# Sherwood Heights - Racecourse Road

## Amendment C208 - Hume Planning Scheme

Urban Design & Landscape Evidence prepared by Craig Czarny, Hansen Partnership for the Victorian Planning Authority

August 2017

Areas of significant slope (PSP pg 14)

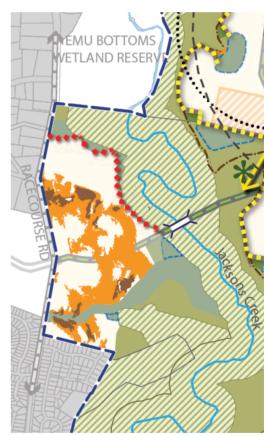
- One physical feature of the land that sets it apart from other parcels designated for redevelopment within the PSP boundary is slope, which ranges between 10 to 15%, with more discrete areas up to 20% (1:5). While I do not advocate viable redevelopment on substantially sloping land (greater than 20%), I believe that careful site planning and design can achieve a successful redevelopment outcome within the intermediate range of 10 to 15%. It is notable from on-site inspection that the land in question represents a local highpoint, with varied graded slopes leading down to Jacksons Creek. As opposed to land which is consistently steeply sloped or severely constrained by drainage and/or vegetation matters, the 'convex' topographical condition of the land provides the opportunity for development on its elevated area, with greater sensitivity required at its lower reaches leading towards the Jacksons Creek floodplain.

View of site from Racecourse Road (north)

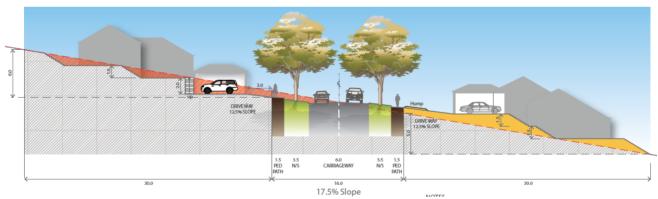
The profile of development on elevated land and hilltops should be clearly subject to landscape and visual amenity tests from key vantage points, including publicly accessible roadways, surrounding land, the Creek Corridor and elevated positions within the new development area to the east. Having undertaken site inspections surrounding the Racecourse Road site, I am satisfied that development on the rising land leading to the Racecourse Road frontage will not compromise the scenic and landscape values of the setting, noting that an appreciation of undulating topography leading down to the Jacksons Creek and the escarpment to the east remain as key landscape elements. Furthermore, I note that views towards the hillside from Emu Bottom Wetland Reserve and other positions along Racecourse Road to the north, include development in the foreground of the ultimate ridgeline (behind this road to the west). In this regard. I believe that future development will sit within the landscape (as opposed to defining its ultimate silhouette). This represents appropriate practice in urban fringe areas, strongly supported by the PSP requirement for substantive landscape cover to parcels, which further aids integration into the setting. To this end, the PSP is appropriately framed in terms of a viewshed analysis.

The PSP as exhibited provides a limited suite of Requirements and Guidelines in relation to **visual** sensitivity, which typically forms an important basis for neighbourhood design in environmentally or scenically sensitive areas. In general terms, PSP G1 seeks to ensure that subdivisions 'respond to the topography and enhance the landscape features and view lines, and in relation to more sensitive locale', PSP R4 requires that 'subdivision of land adjacent to a sensitive visual interface and must provide for an interface outcome consistent with those set out in the Regionally Significant Landscape cross sections'. While the site on Racecourse Road has an interface with a Conservation Area to the north and north-east of the designated residential land (and is therefore a Sensitive Visual Interface), there is no relevant cross-section guiding development in this particular location. I note that cross-sections at Appendix 4.2 specifically relate to Regionally Significant Landscapes with escarpment top development and not development at the interface with a conservation area. In my opinion, further design guidance is required at this interface (preferably through cross-sections) illustrating development setbacks and the preferred landscape response.
